Staff Report & Recommendation

Historic Preservation Board

HPB0616-0041, 230 Lincoln Road.

The applicants, Camford Corp and Carib Mall Associates LLC, are requesting a Certificate of Appropriateness for the introduction of signage facing Lincoln Road

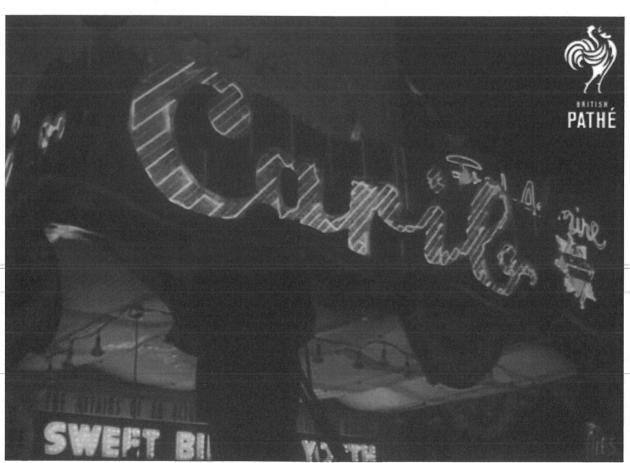
Staff has only minor concerns with the proposed signage. First, staff believes that the introduction of two west facing "Ross Dress For Less" signs is excessive, and would recommend that the west facing sign located on the marquee be eliminated. Second, staff would recommend that the depth of the channel letters on the marquee be increased to a minimum of 6" to be more consistent with the intent of the Lincoln Road Signage District and the original marquee sign as seen in the image below.

- b. The sign proposed for the west side of the marquee shall not be permitted.
- c. The depth of the channel letters located on the marquee shall be no less than 6", in a manner to be reviewed and approved by staff consistent with the Certificate of Appropriateness Criteria and/or the directions from the Board.
